Delegated Report		Analysis sheet		Expiry Date: 16/12/2022		
		N/A / attached		Consultation Expiry Date: 19/11/2022		
Officer			Application Number(s)			
Sofie Fieldsend			2022/2529/P			
Application Address			Drawing Numbers			
71 Avenue Road London NW8 6HP			See decision notice			
PO 3/4	Area Team Signature	C&UD	Authorised Officer Signature			
Proposal(s)						
Erection of a two storey, single family dwellinghouse (Class C3) with basement and accommodation in the roof space, following the demolition of existing						
Recommendation:		Refuse planning permission				
Application Type:		Full Planning Permission				
Conditions or Reasons for Refusal:		Refer to Decision Notice				
Informatives:						
Consultations						
Adjoining Occupiers:	No. notified	00	No. of responses	2	No. of objections	2
			No. electronic	00	No. of comments	00
Summary of consultation responses:		<p>Site notices were displayed on the 26/10/2022 and the consultation period expired on the 19/11/2022.</p> <p>2 objections were received from neighbouring properties and their objections are summarised as follows:</p> <ul style="list-style-type: none"> Heritage: Harm to setting of the Elsworthy Conservation Area and the St

Image 2: Aerial view showing existing boundary between application site and No.69 Avenue Road.

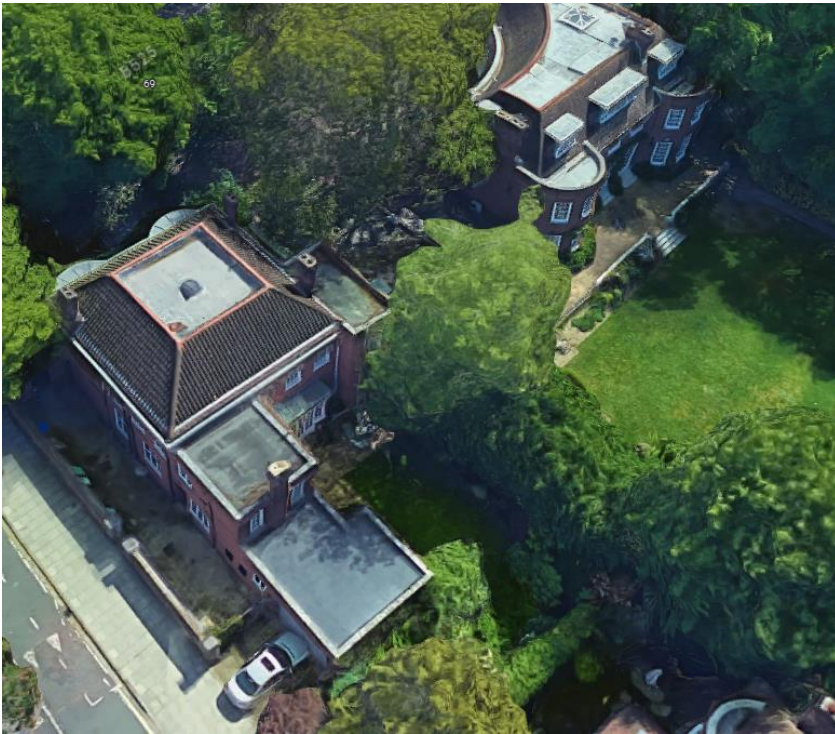
6.3 No.69 Avenue road also raised concerns about the proposed rear patio impacting on the privacy to their garden unless effectively screened. The rear patio is located at ground/garden level and is raised 0.38m high. It is noted that within the garden of No.69 the side boundary it is heavily screened by mature trees as shown in Image 2. Nonetheless details of the final boundary treatment to ensure the raised patio does not impact their privacy could be secured by condition if the development were acceptable.
